SUBJECT: M20J INDUCTION AIR/ALTERNATE AIR DOOR RETROFIT

MODEL/S/N
AFFECTED: M20J - S/N 24-0001 THRU 24-3243

SERVICE BULLETIN M20-250 B
 DATE: 12 - 95
 Page 2 of 2

FIGURE SB M20-250 B-1

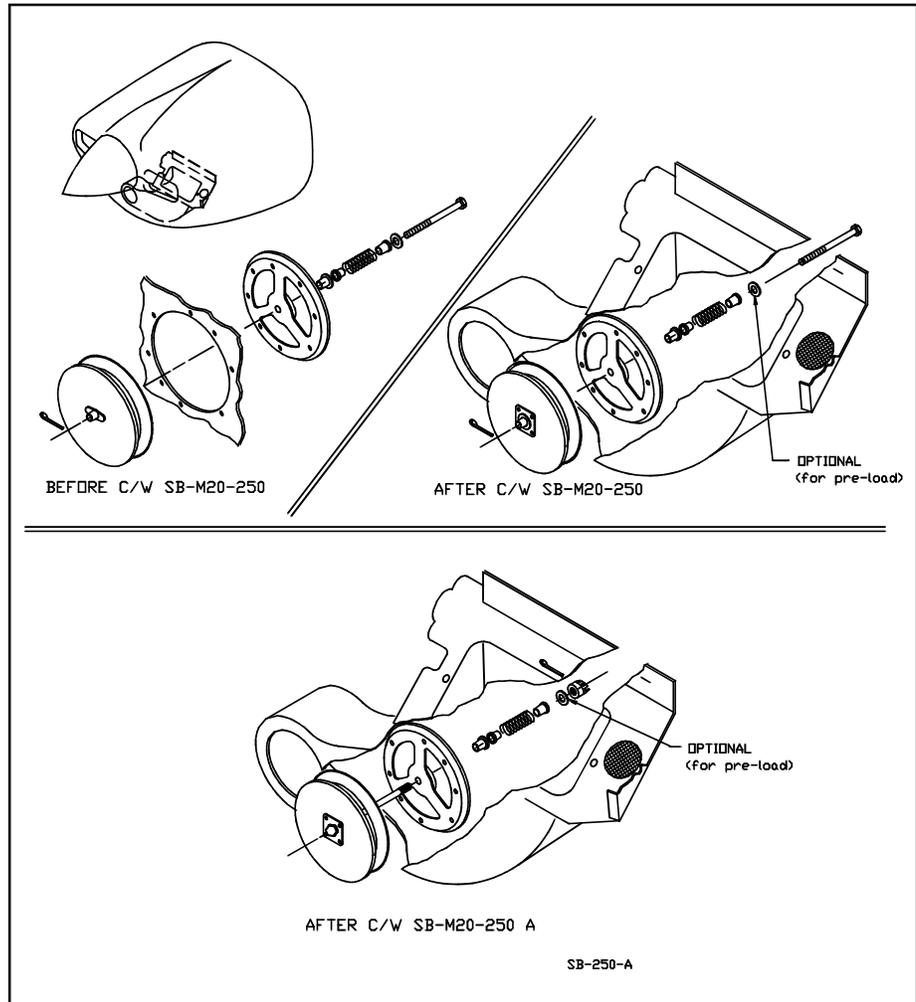
Revision B is prepared to change part number call out for a new style nut and larger OD cotter pin. Revision A was prepared to change the configuration of the plate assembly (formely "nut plate assembly") and install this new plate assembly onto the existing alternate air door on aircraft which have complied with original SB M20-250, dated 11-15-91. If SB M20-250, Revision A, has been complied with, and all components are within wear tolerances, only the nut and cotter pin need to be replaced in accordance with SB M20-250, Revision B. Kit number SB M20-250 B-1 contains all components necessary to retrofit an aircraft to the current configuration. Kit number SB M20-250 B-2 contains only the new nut and cotter pin. **The FAA has indicated that an AD is to be issued to make the incorporation of this SB mandatory.**

FIGURES/
 TABLES:
 SEE BEFORE AND AFTER CON-
 FIGURATIONS BELOW,
 SB M20-250 B-1.
